MSEX2024A-03

S E R V I C E N O T E

MSEX2024A – Oscilloscope, Mixed Signal, 4+8 Channel,
200MHz

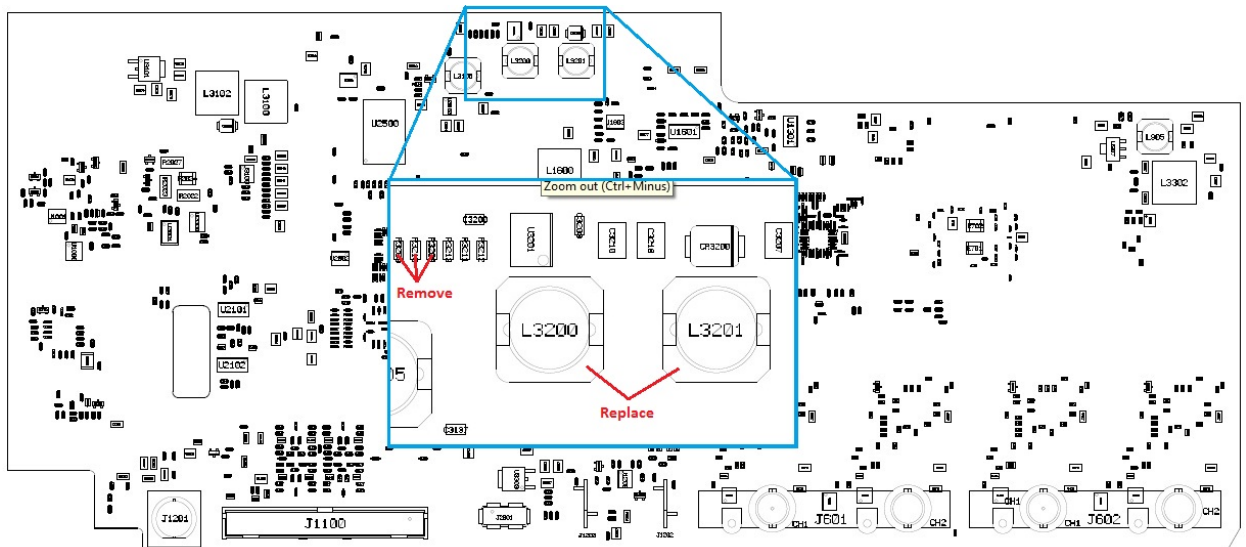
With the oscilloscope power turned on and while under normal operation, the unit emits a hissing noise.

2. As the picture indicates, remove the three resistors (0699-7209, 1 Ohm) located at R3208, R3209, and R3210. They are not to be replaced.
3. Remove as well the two inductors (9140-6474, 100uH) located at L3200 and L3201 and replace them with inductors with part number 9140-6151 (68 uH).
4. Re-assemble to the point where the unit could be powered up to verify that the hissing is indeed gone. If the hissing is not gone, please, check modifications.
5. When the hissing is gone, put oscilloscope back together.
